PRODUCT CHANGE NOTIFICATION

Date: November 06, 2015
PCN: PCN LEDIL 112 a, b, c, d

Subject: PCN 112.c – Change of product mechanical design

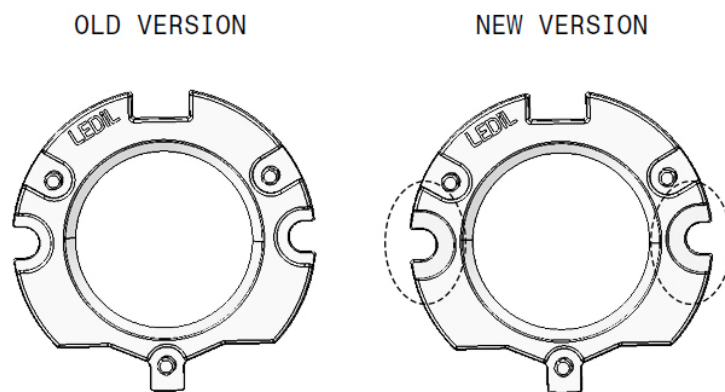
Description: As part of our continuous improvement process regarding the quality of our products LEDiL has widened the area for screw heads in C13709_PF-SOCKET-VER013-18 to allow fastening with washers and spring washers. This change doesn't cause optical changes to products.

Changes: Area reserved for screw heads has been enlarged from 6.1mm to 7.5mm.
